JOINT APPLICATION FORM
Department of the Army/TVA

This project involves the construction of a new raw water intake to supply the Hallsdale Powell Utility District serving the North section of Knox County and some areas of Anderson County. The District presently serves 22,000 customers. The facility is required due to the phenomenal growth in the area

I have responded to questions that you raised to the proposed intake for Hallsdale Powell Utility District.

Re: Hallsdale Powell
Raw Water Intake
Melton Hill Reservoir
Bull Run Mile 2+
Parcel MHR - 904

PERMIT DRAWING	
HALLSDALE POWER RAW WATER INTAKE	
SCALE	DRAWN BY
H: 1"=40'	RGC, II
V: 1"=4'	
ANDERSON CO., TN.	SURVEYED BY
	ROBERT G. CAMPBELL & ASSOC., L.P.
DATE	PROJECT NUMBER
2-15-00	02200

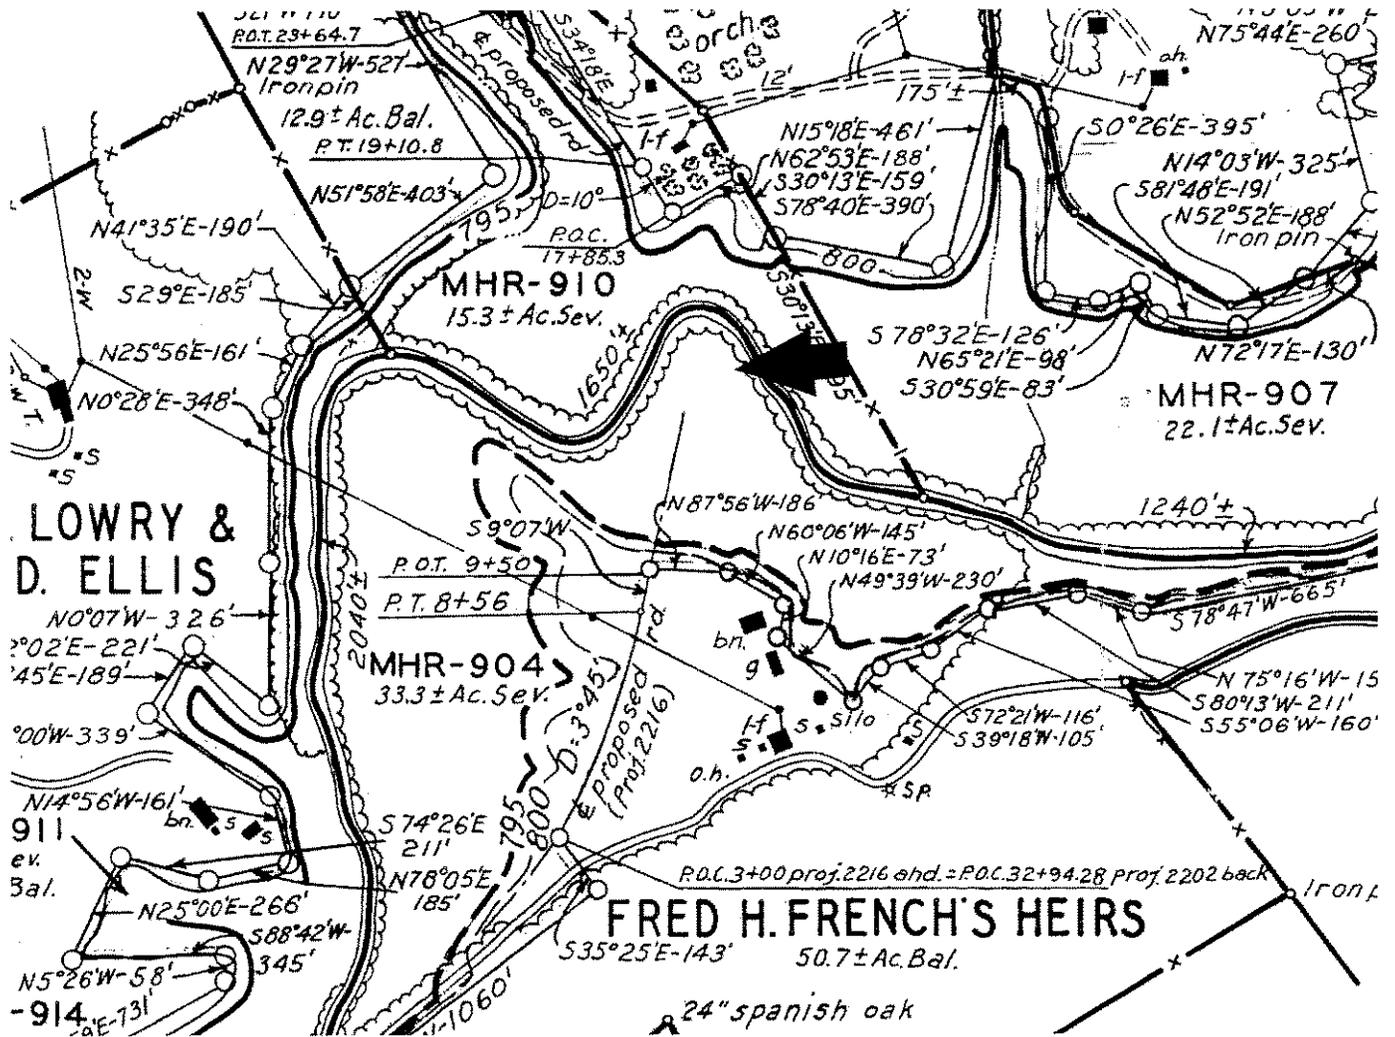
8. Length of pipe
There will be a total length of 270 feet from our property line. Of that, 87 feet will be out of the ground and exposed in the channel

9. Method of Anchoring pipe.

Pipe will be anchored with concrete supports placed every 20 feet apart in the exposed section. These anchors will have foundations that extend into the lake bottom at sufficient depth to provide support. Each support will be secured by threaded bolts and a plate over the top of the pipe section
